**TOMBALL INDEPENDENT SCHOOL DISTRICT
RFP-CSP #1004-26 – TOMBALL CREEKSIDE PARK JH AND TOMBALL MEMORIAL HS
ATHLETIC IMPROVEMENTS**

Addendum No. 05

ADDENDUM NO. 5
TO THE
DRAWINGS AND PROJECT MANUAL
FOR
**TOMBALL ATHLETIC IMPROVEMENTS
TOMBALL ISD
TOMBALL, TEXAS**

CIVIL CONSULTANT, ADDENDUM 5

DEMOLITION & SWPP PLAN

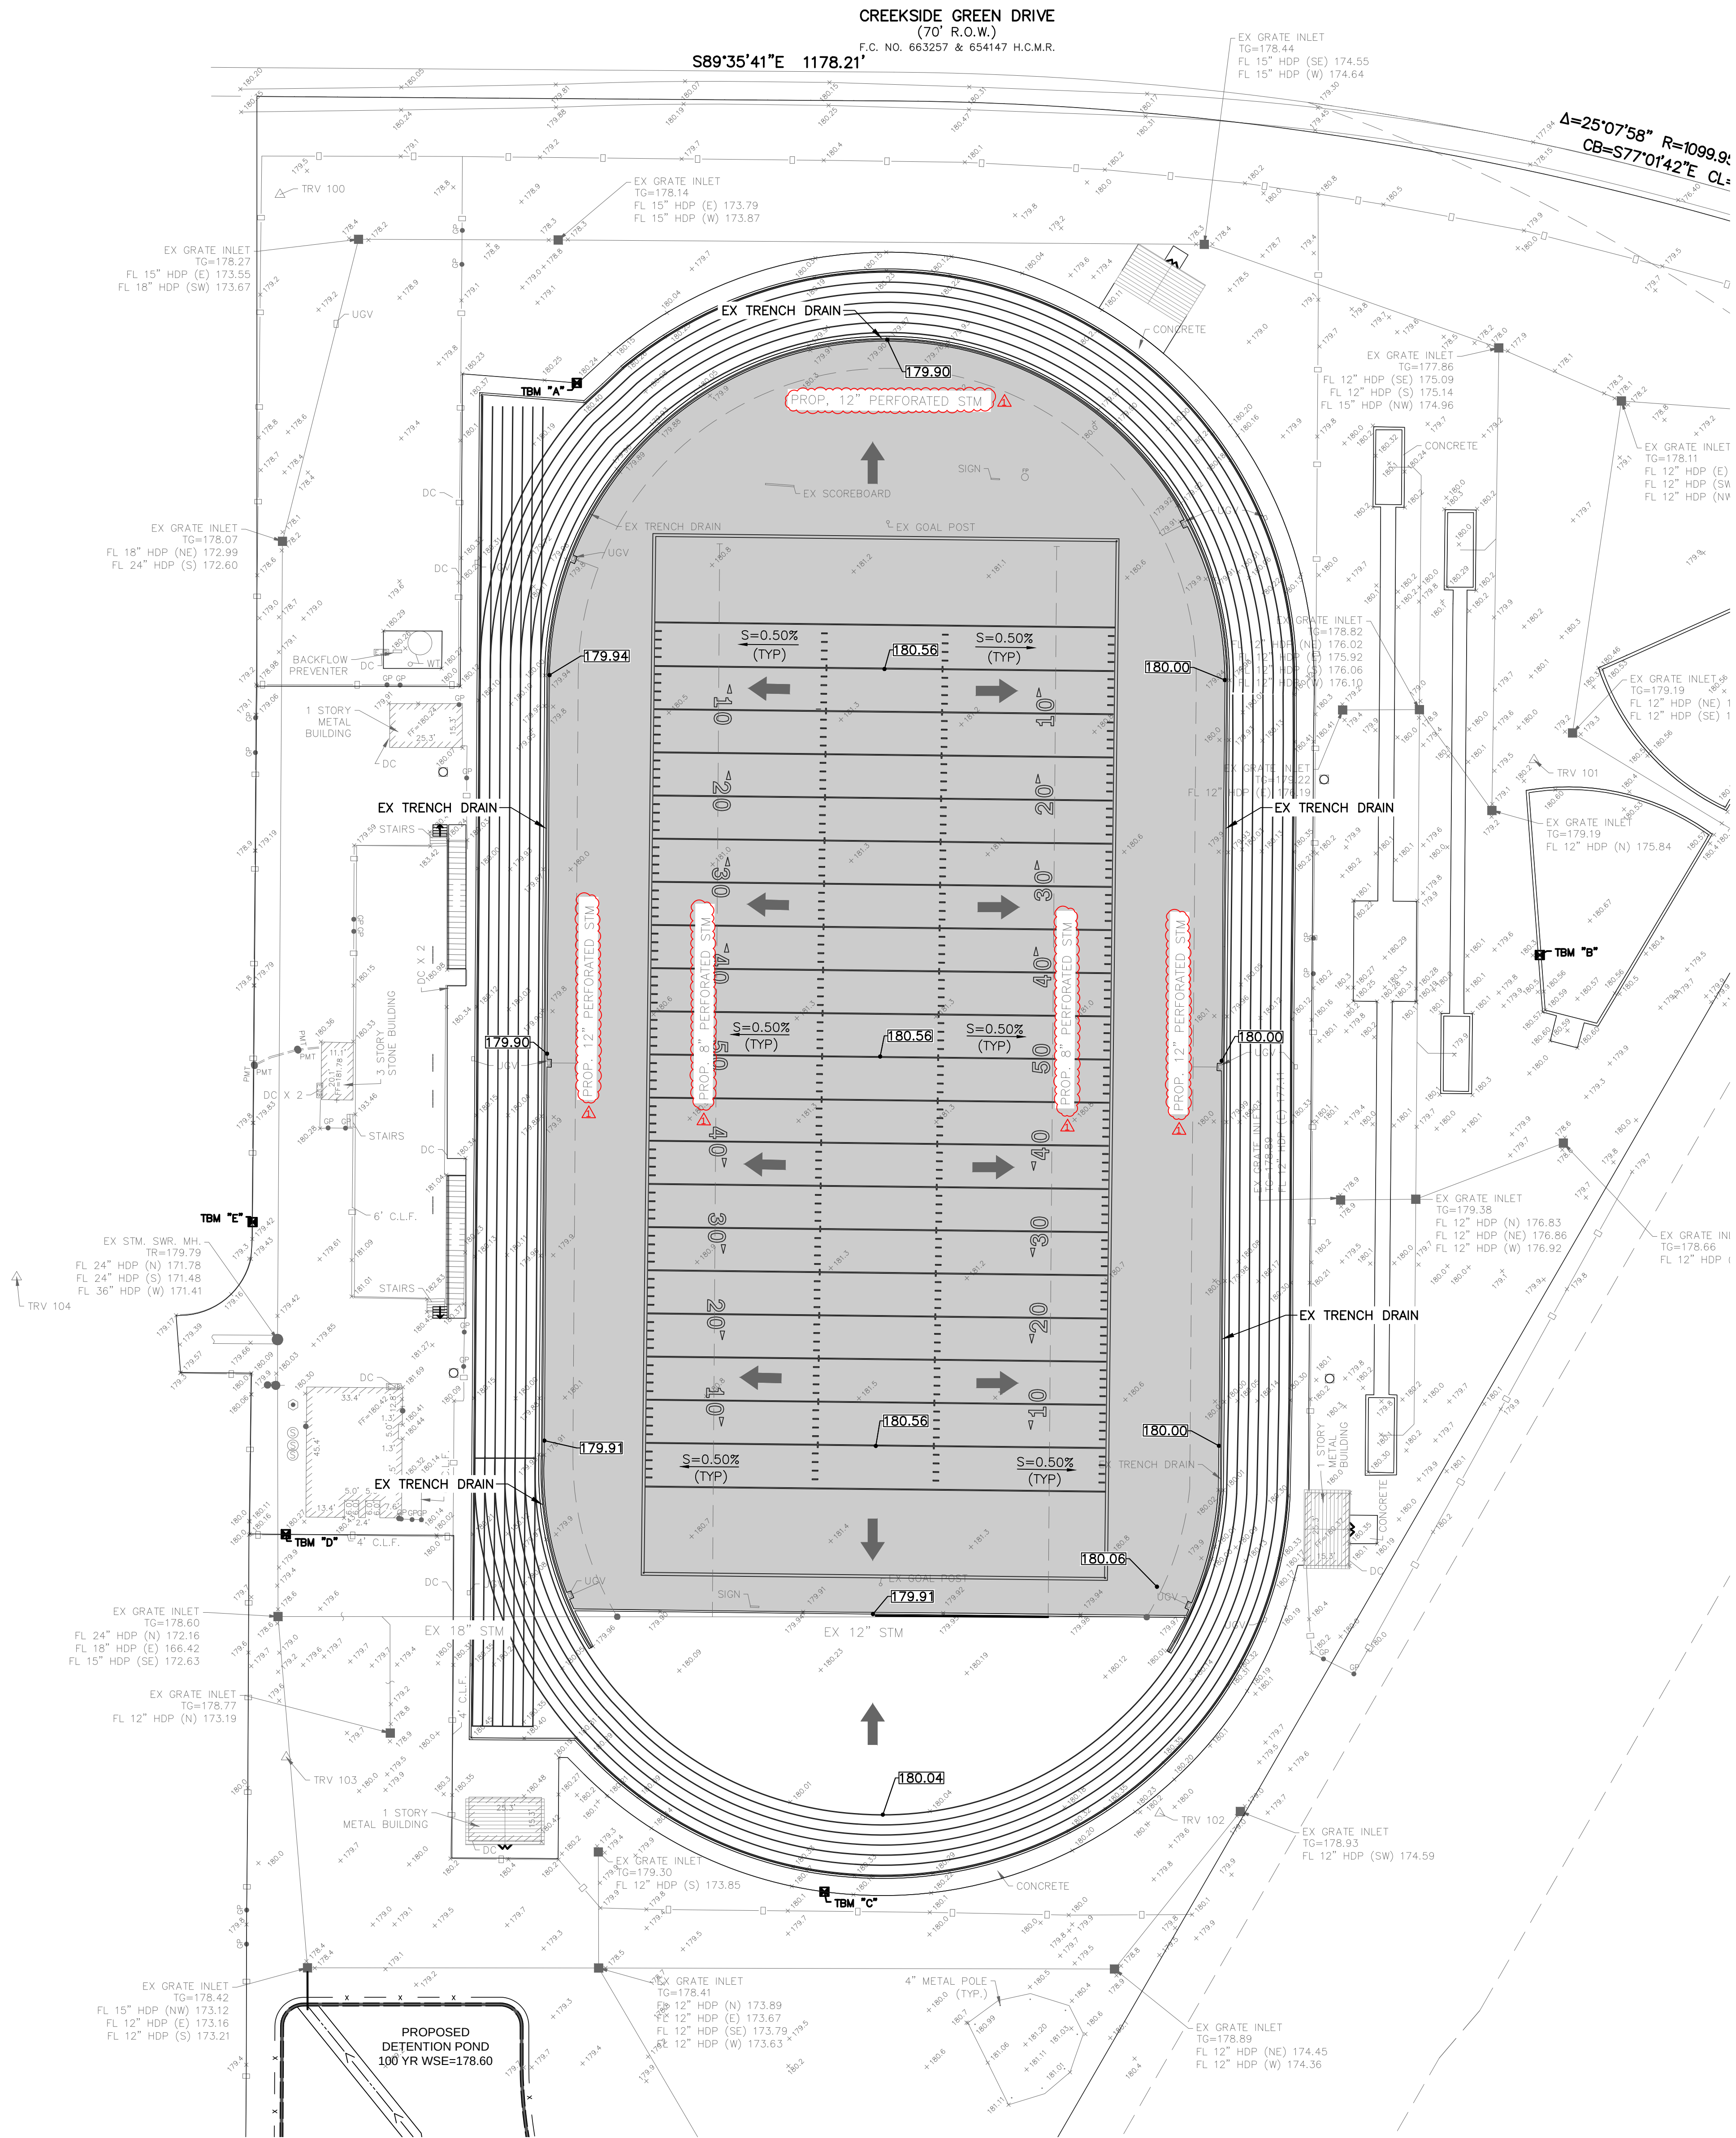
1. C2.00 – DEMOLITION & SWPP PLAN

- A. All existing perforated storm pipes under the field will be removed.

STORM &
DETENTION PLAN

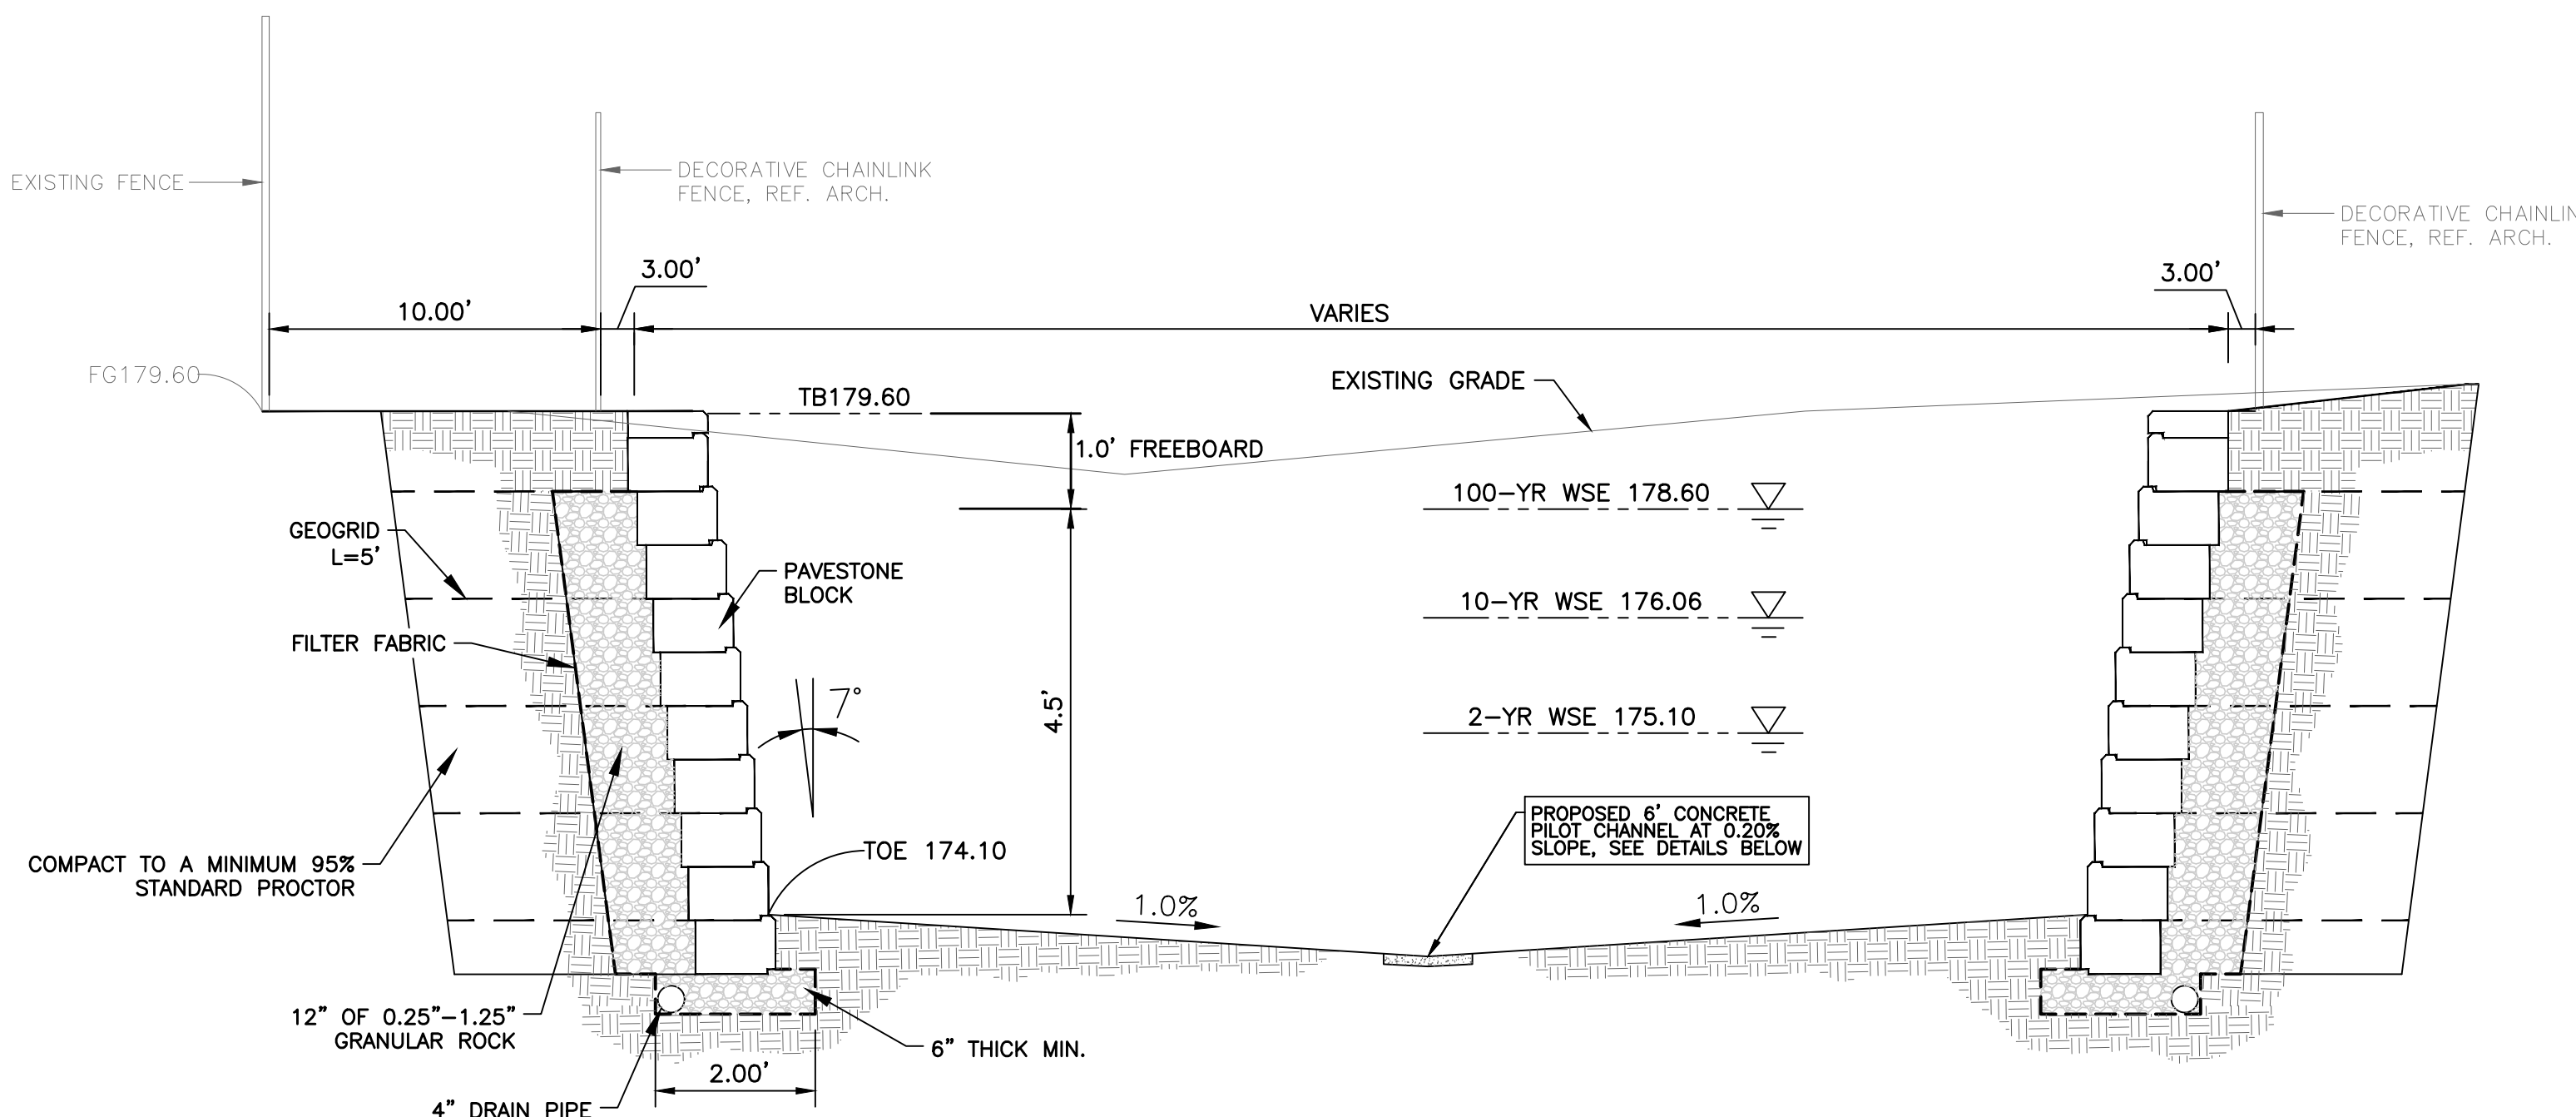
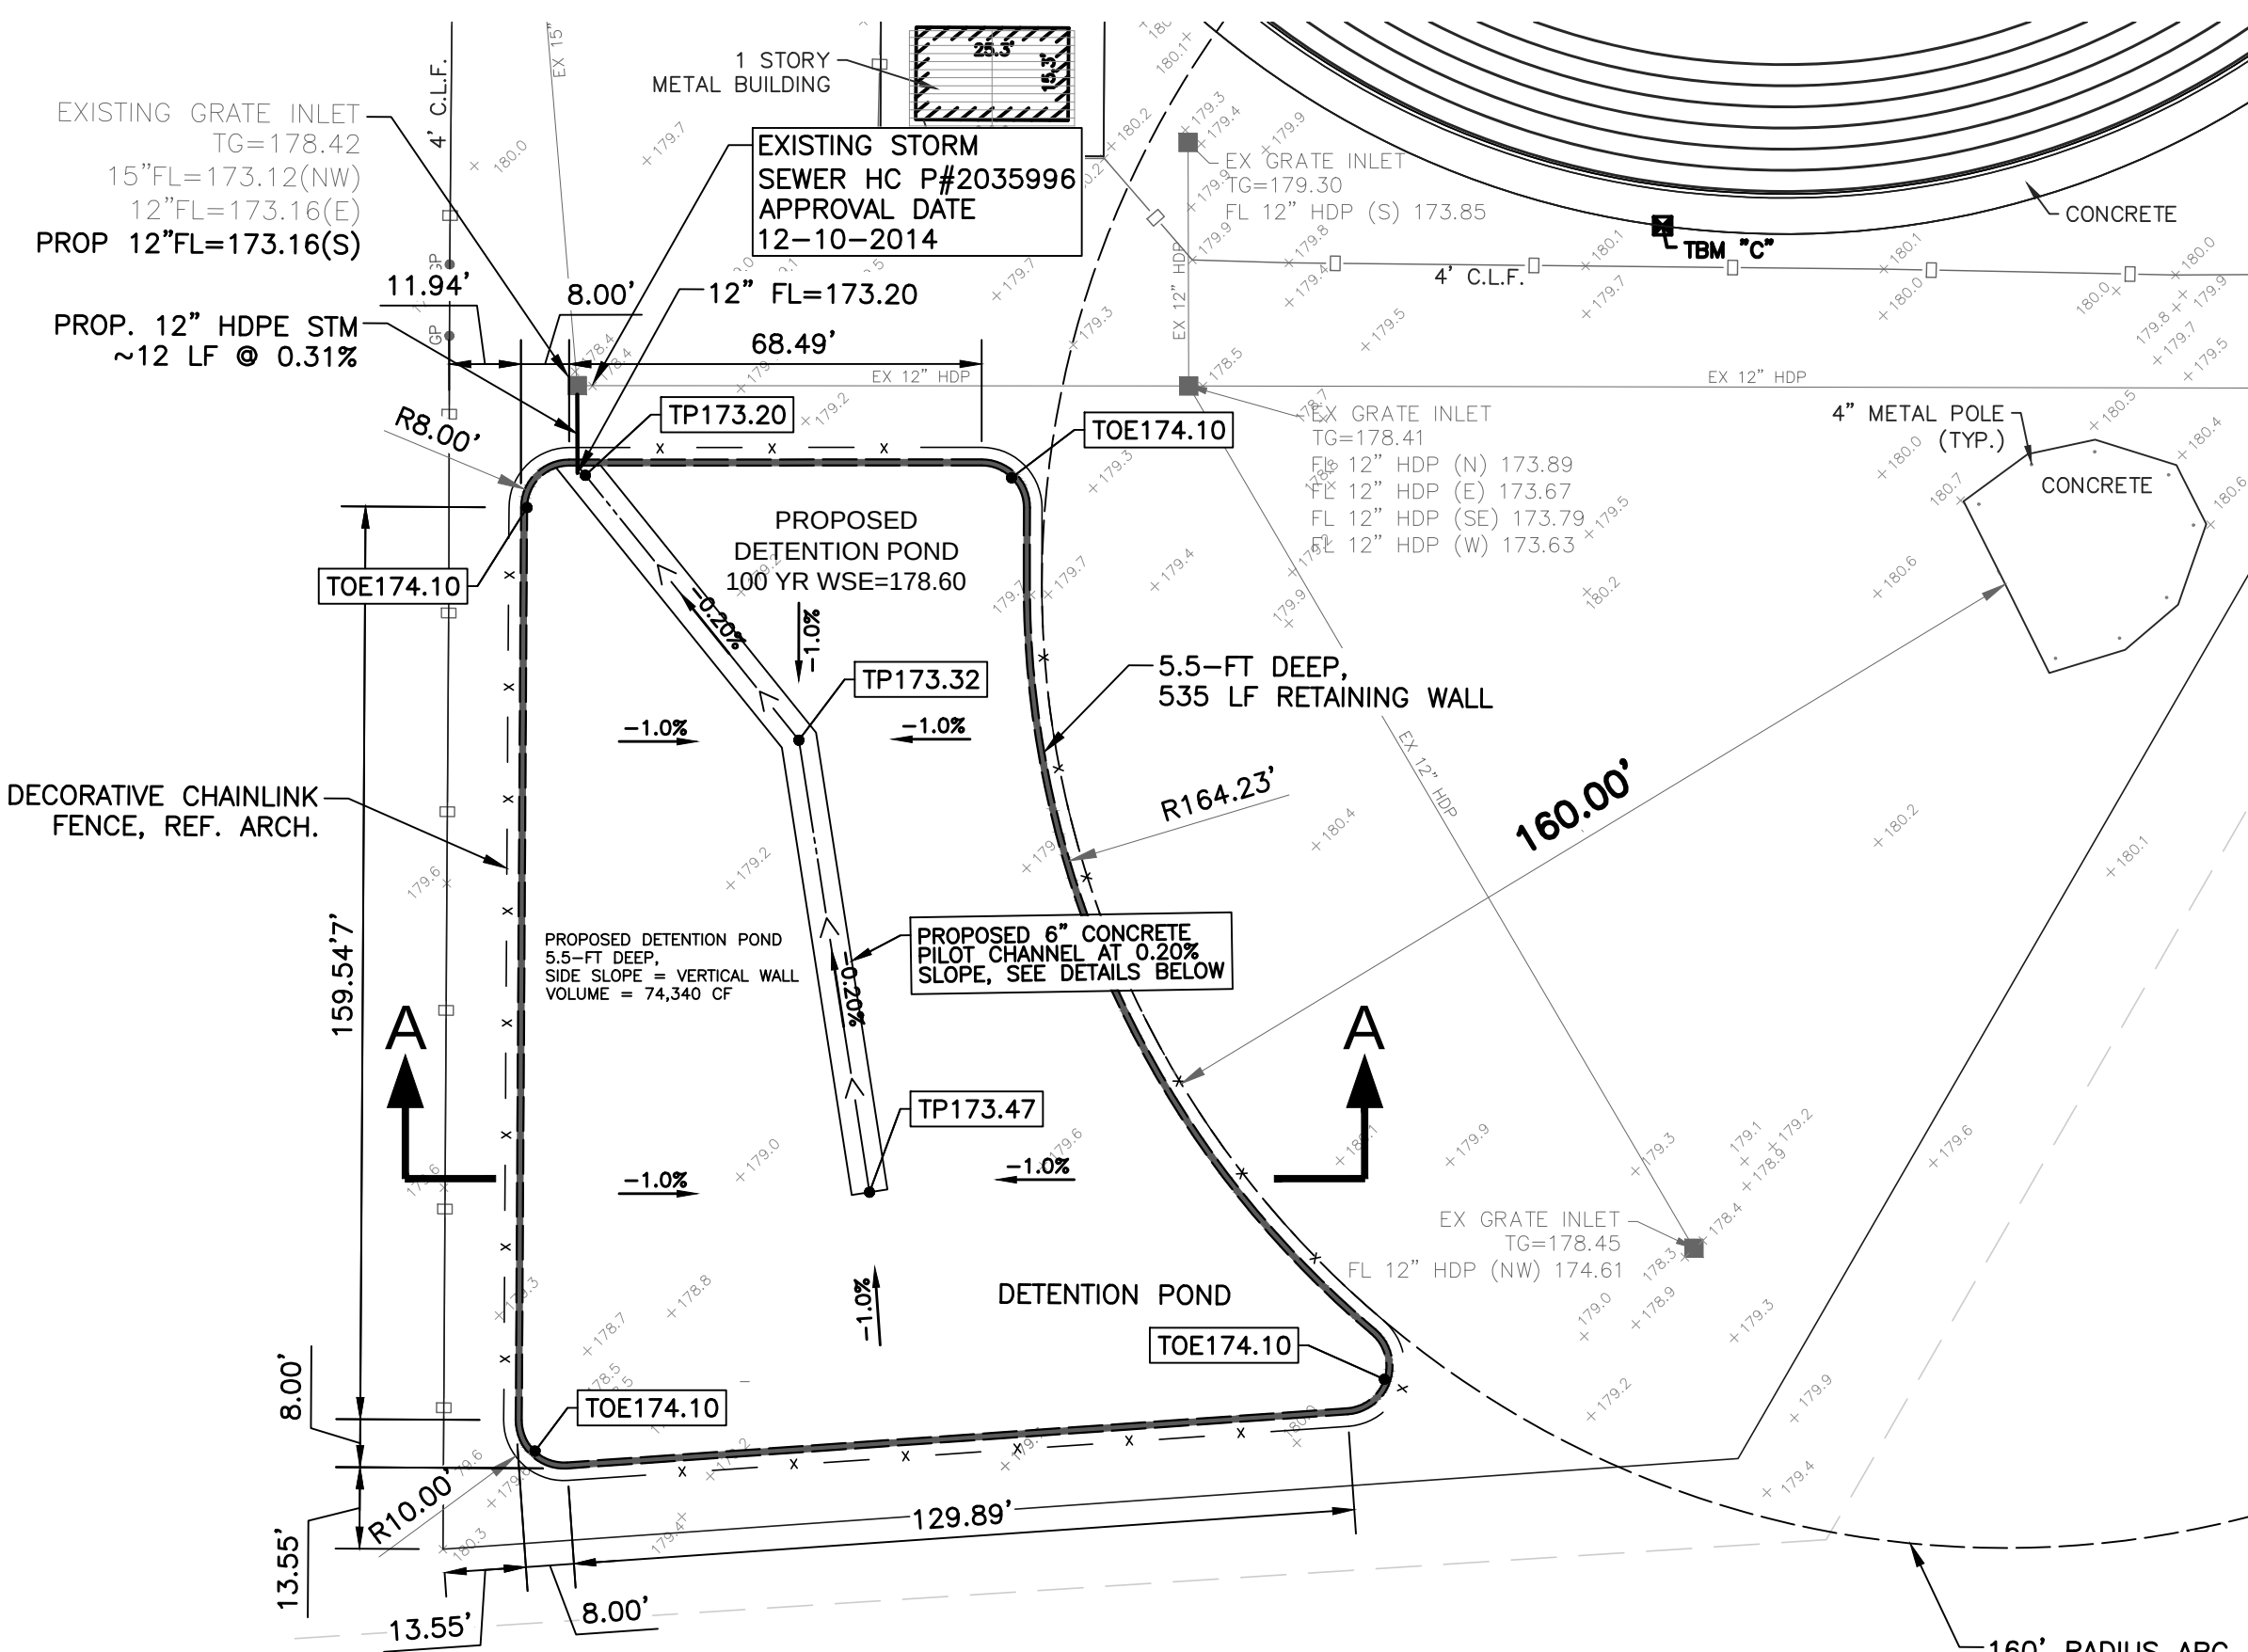
4. C5.00 – STORM & DETENTION PLAN

- A. Added new perforated storm pipes under the new synthetic field to replace the existing perforated storm pipes that's being removed.
